PLANNING COMMISSION AGENDA
City Commission Chambers - City Hall
625 Center Street, Oregon City, Oregon 97045
March 14, 2011 at 7:00 p.m.

COMMISSION REPORT: CITY OF OREGON CITY

| SUBJECT: | CU 10-03 and CP 10-03 Conditional Use and Concept (General) Plan: South Fork Water Board submitted a Conditional Use Permit (Planning File CU 10-03) and General Development Plan (Planning File CP 10-03) to upgrade the water treatment facility on Hunter Avenue. |

FILE NO.: CP 10-03 Concept (General) Development Plan
CU 10-03 Conditional Use

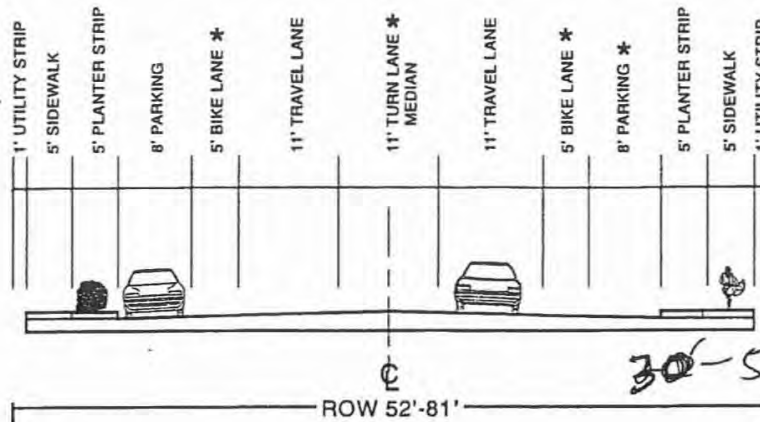
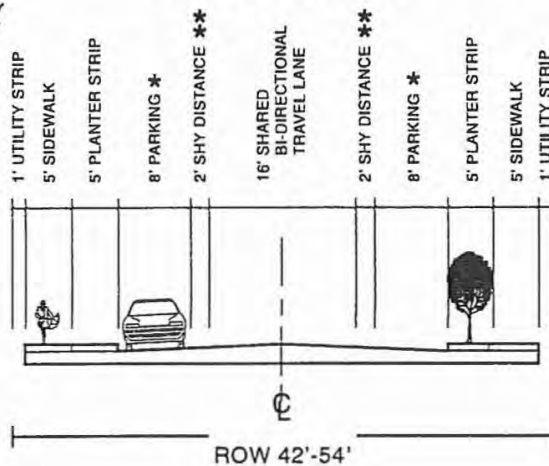
The City requires 35.5 feet from centerline; therefore, applicant shall dedicate ROW to provide 35.5 feet from centerline.

Row
Hunter - need 6.5'
Thurman - OK

Hunter &
Thurman
No sidewalk
on Thurman
or Hunter
due to
security.
Hunter to
have full
32' width
of AL to
allow peds/
bikes an
area to
walk.

Figure 1. Annotated road section drawing for Swan Avenue from pre-application conference notes.

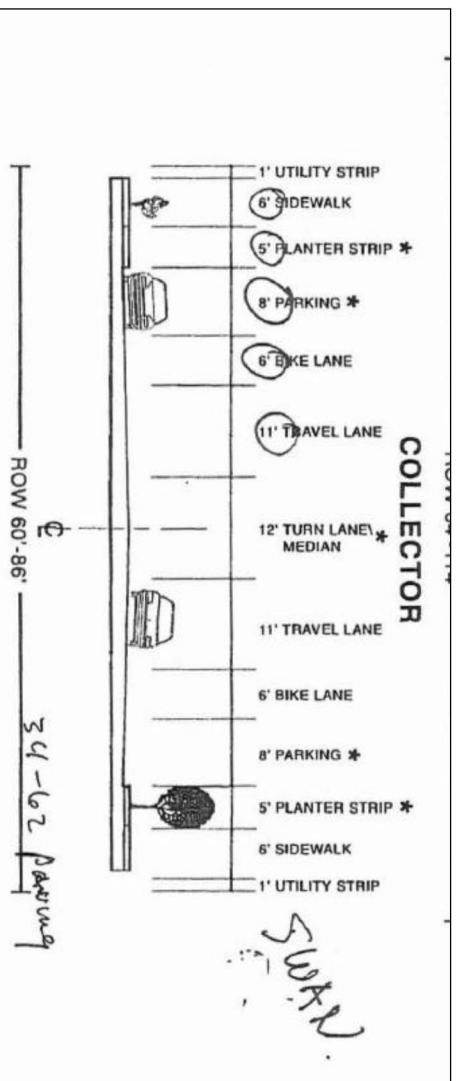
In the pre-application materials and through discussions with City staff, the City has indicated that it will require improvements on all three street frontages abutting the SFWB property. The most significant request is to Swan Avenue, which is designated as a collector street in the City's Transportation System Plan. The City's plan for improvements on this frontage includes sidewalks, planter strips, parking, bike lanes, and travel lanes per **Figure 1**. To achieve this, additional SFWB property would have to be dedicated to the City.

Figure 2. Annotated road section drawing for Hunter Ave. and Thurman St. from pre-application conference notes.

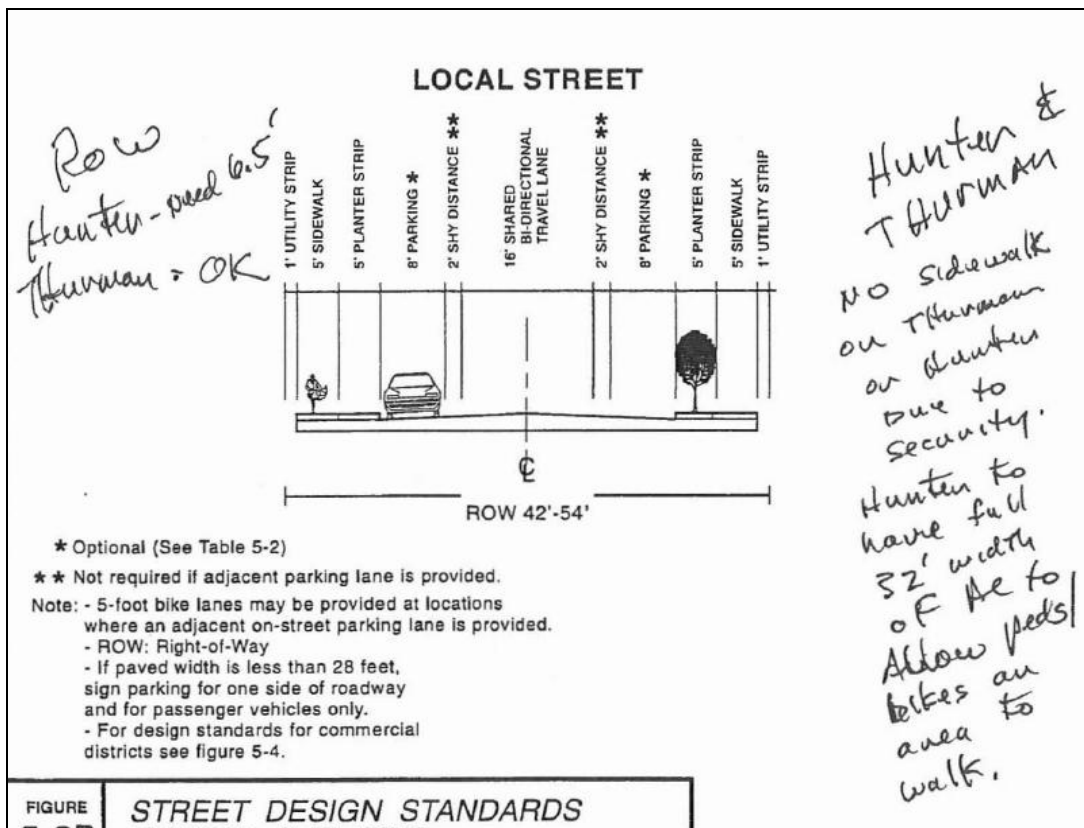
For the other two frontages along the SFWB property, Hunter Avenue and Thurman Street, the City's plan for improvements call for sidewalks, planting strips, and parking on both sides per **Figure 2**. All of these improvements would require SFWB to dedicate some of its land to the City. Currently, Hunter Avenue does not have sidewalks on either side. Thurman Street has a full sidewalk and curb on the opposite side of the street from the SFWB property.
